Drawing Title: DOOR & WINDOW SCHEDULE AND DETAILS. Includes an Approved stamp.

Phase: CONSTRUCTION DOCUMENTS. Includes Fully Sprinklered notation.

Project Title: RENOVATE AND CONSOLIDATE INPATIENT FUNCTIONS. Includes location (Fort Meade, South Dakota) and drawing number AE01.

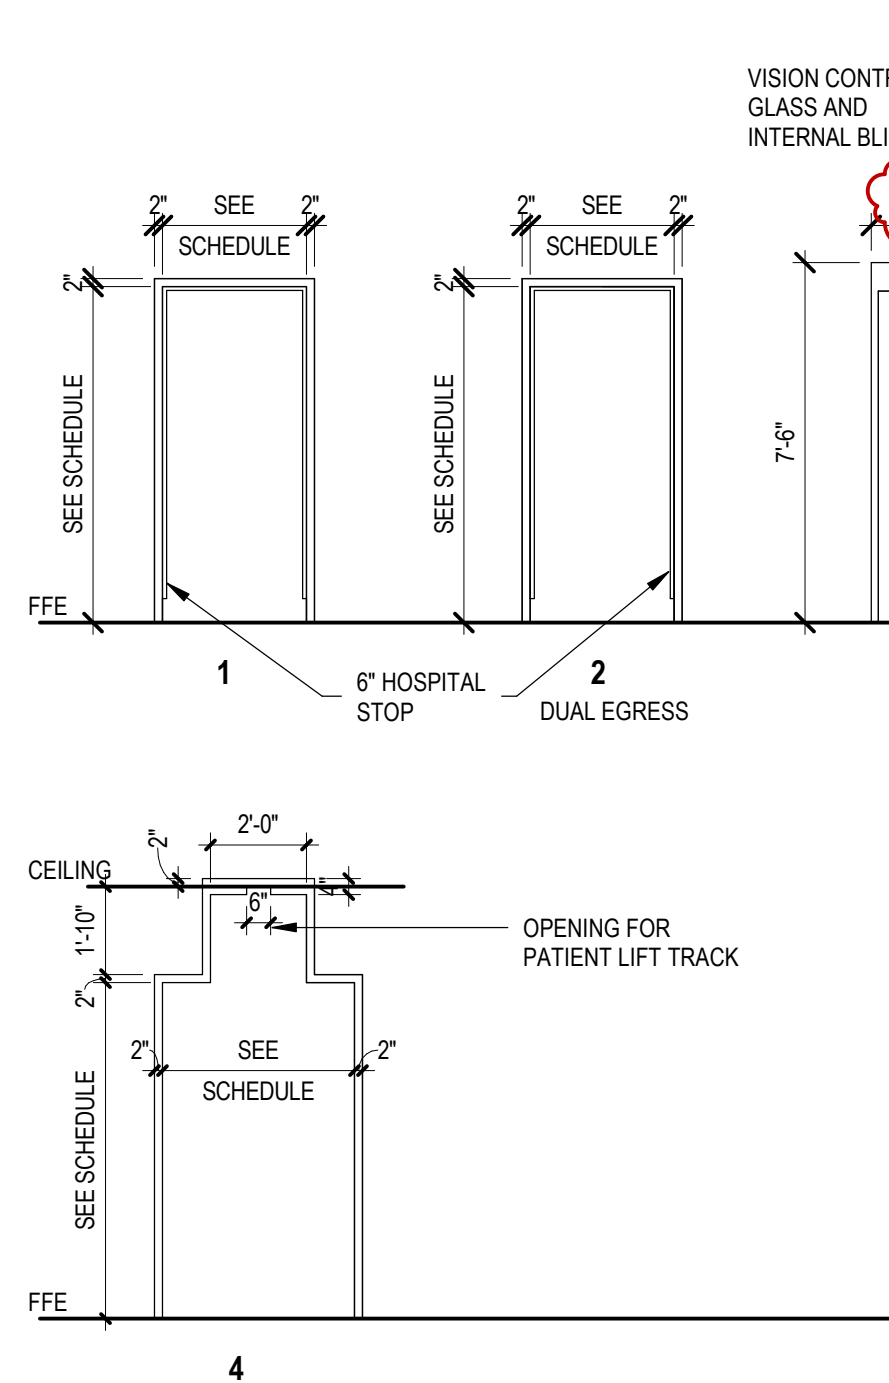
DOOR SCHEDULE table with columns for Door #, Size, Type, Material, Panel Type, Glazing, Frame, Fire Rating, and Remarks. Includes handwritten annotations and red circles around specific entries.
